Government of India
Ministry of Environment, Forest and Climate Change
(Forest Conservation Division)

Subject: Proposal for seeking prior approval of the Central Government under section 2 (1)(ii) of the Van (Sanrakshan Evam Samvardhan) Adhiniyam, 1980 in favour of M/s Fatik Das for non-forestry use of 5.4 ha Reserved Forest for operation of Gopeswar Stone Quarry & Mining Zone Area under North Kamrup Division in Kamrup District in the State of Assam (Online proposal No. FP/AS/QRY/37021/2018)- regarding.

Sub: Site Inspection Report for diversion of proposal for 5.40 ha of forest land for operation of Gopeswar Stone Quarry & Mining Zone Area under North Kamrup Division in favour of Sri Fatik Das Guwahati.

Photographs of the proposed site for operation of Gopeswar Stone Quarry & Mining Zone Area(5.40 ha) under North Kamrup Division

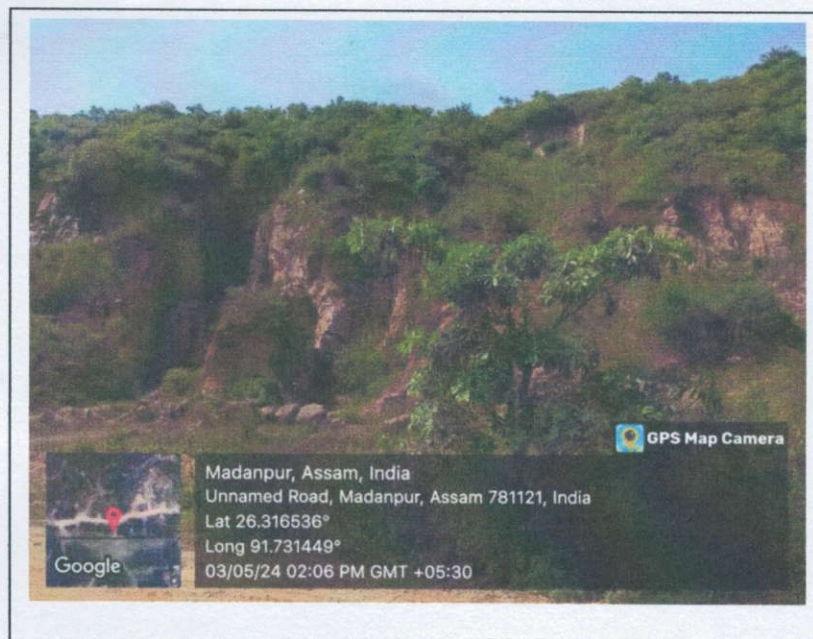
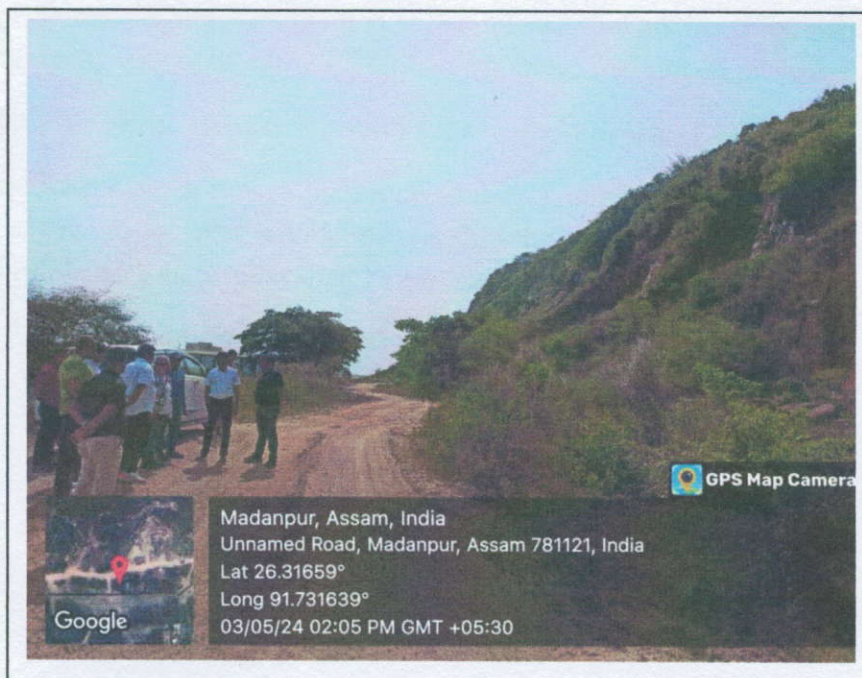
Proposed site of Gopeswar Stone Quarry & Mining Zone area under North Kamrup Division

The existing katcha road where the proposed approach road (0.02 ha) is connected to the mining site.
